Subject Property: 5A Lorenz Industrial Parkway, Ledyard

Plan Designed by: Peter Gardner, L.S. Plan Date: **10/1/2024** Last Revision Date: **12/11/2024** Date Paid: **11/15/2024**.
The plan and associated information submitted to our office on **11/14/2024** for a proposed 2 office commercial building with public water and private septic at the above stated property, in the Town of Ledyard, is:

Approved w/conditions: Complies with the requirements of Section 19-13-B103 of the Connecticut Public Health Code; See conditions below.

PLAN SHOWING PROPOSED BUILDING ON PROPERTY OF A & R ASSOCIATES INC. 5A LORENZ INDUSTRIAL PARKWAY LEDYARD, CONNECTICUT
 SCALE: 1" = 20'
 OCTOBER 2024
 REVISED: DECEMBER 11, 2024

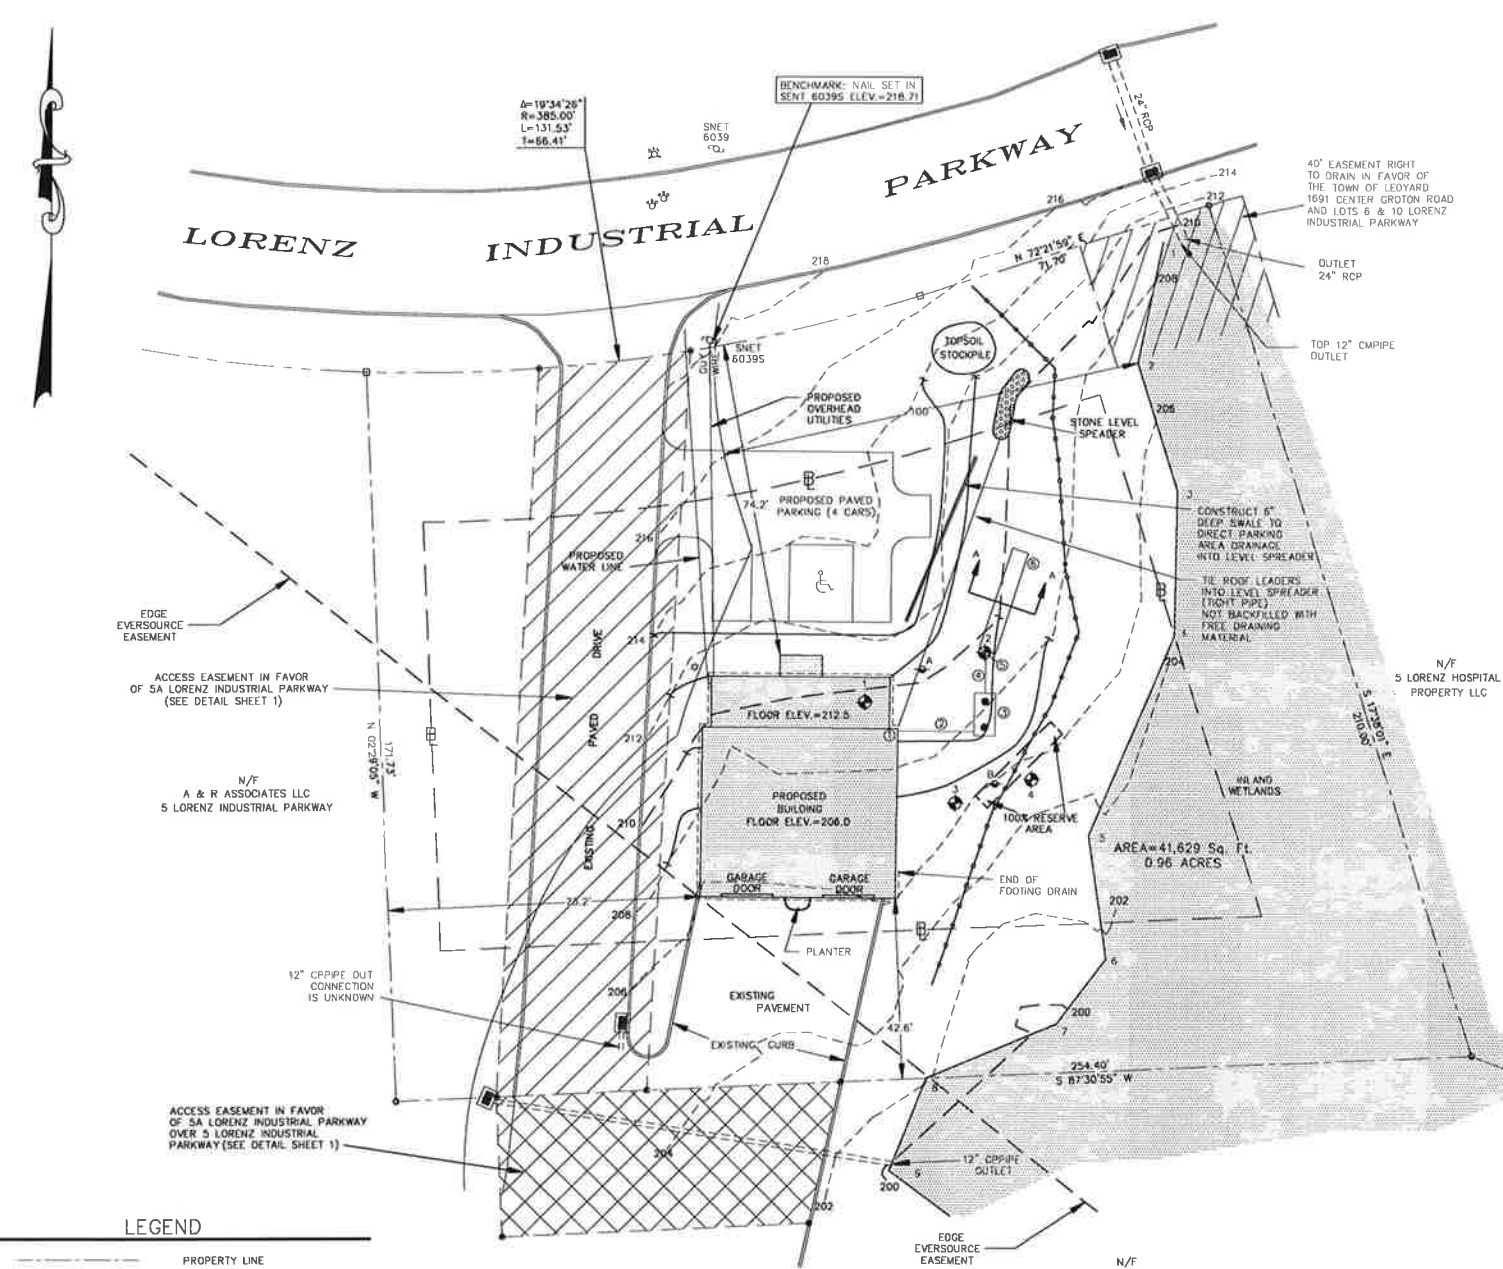
1. The plan proposes one row of 25LF in length, of Mantis 536-8 Low Pro to be set at a base elevation of 207.00', and gravity fed by a minimum 1000-gallon tank.

2. Confirmation test pit required at Northeast end of the primary leach field prior to installation.
3. A walkthrough upon completion of the construction of the house will be required prior to the issuance of the permit to discharge.

4. Footing drains shall remain >25' from all septic components. Shall be tight piped anywhere within 25" and the trench shall be backfilled with non-free drainage material.

5. A full sized to scale print of approved plan shall be provided to LLHD prior to issuance of the permit to install.
6. Stable benchmark adjacent to proposed building and sewage disposal system. Installer should not be required to transfer benchmarks when considerable difference (more than 10' to 15') exist between the benchmark and leaching area. If the benchmark is disturbed prior to construction, the engineer should set another one for construction purposes.

7. All tanks requiring risers shall maintain the original covers on the tanks, have riser covers that weight at least 59 lbs. and/or install a safety device below the riser to prevent individuals from falling into a tank. All below grade tank or riser cover handles shall contain or be fitted with a material that can be located with a metal detector

Handwritten notes:
 209 - 208.50 = .50 prov
 210 controllable
 84" (7')
 36" (3')
 207.00 MAX BTM
 Proposing 207.00

Handwritten note:
 Approved w/ conditions ORm 12/17/24
